ARCHITECTURAL REVIEW BOARD REGULAR MEETING AGENDA

June 11, 2026

STAFF REPORT

DATE: June 11, 2026
TO: Architectural Review Board
FROM: Renee Burton, Division Director of Planning
RE: Certificate of Appropriateness PZ25-00583, filed by Justin Williams, for the installation of a new roof at Parcel 20119 (507 Holbrook Avenue).

RICHARD MORRIS ARCHITECTURE
10 NINTH ST.
LYNCHBURG, VA 24504
434-209-0618
www.rma-designs.com

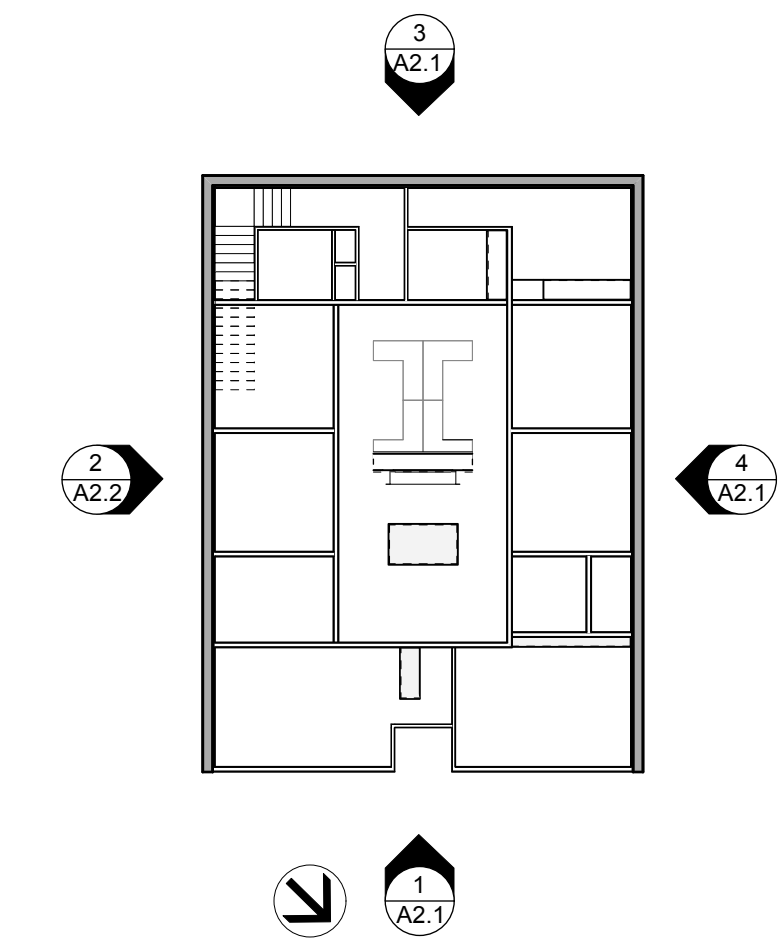
the previous application. Updates to the design include removal of the awning, building moniker, prohibited materials, and historically incorrect window style. Staff's concerns remain in place regarding the proposed signage and encourage the Board to ensure it is attached to the building and not an inlay of the building in comparable material. Staff also recommends the applicant provide more details regarding the windows and entrance door materials, as well as the arch of windows above the entrance door.

Planning staff recommends approval of Certificate of Appropriateness PZ26-00354, filed by Mark Willard, for the design "Option A" only at Parcel 20310 (211 & 215 North Union Street) with the requirement for further detail of the following items before final approval:

NO. SET	DATE	BY	DATE	NO. SET	DATE	BY	DATE
CITY OF DANVILLE, VIRGINIA PARKS AND RECREATION				CURB MARKET PARKING LOT			
Paving and Fencing				SCALE 1" = 30'			
				SHEET 1 OF 1 SHEETS

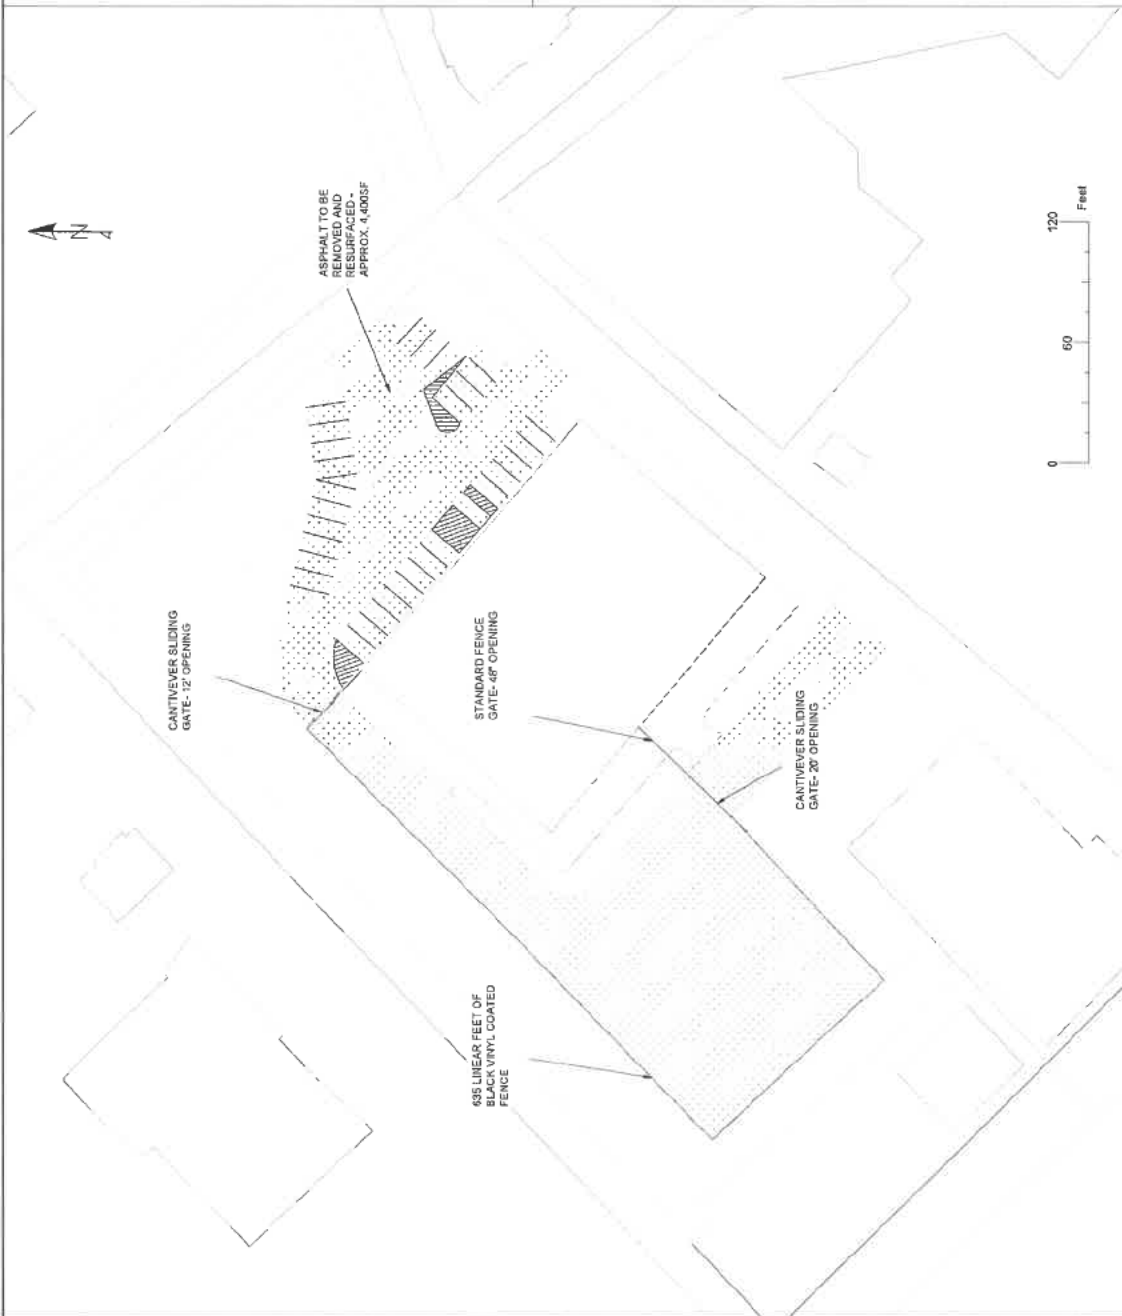
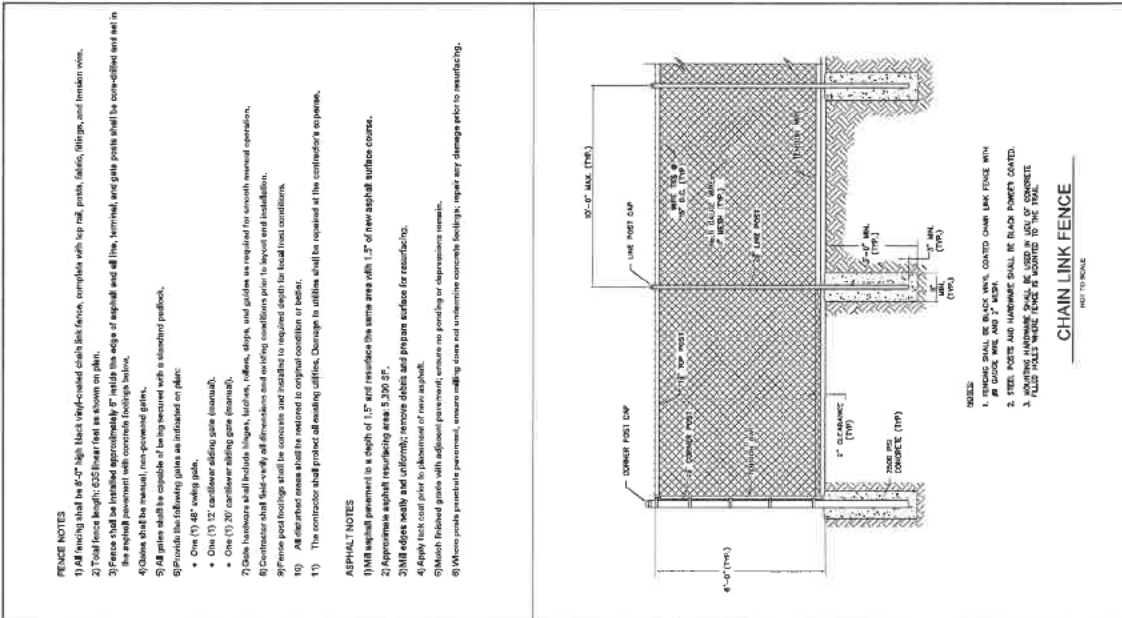
Planning staff recommends careful consideration of Certificate of Appropriateness PZ26-00362, filed by the City of Danville, to install a fence at Parcel 26488 (614 Spring Street) given the proposed materials and height.
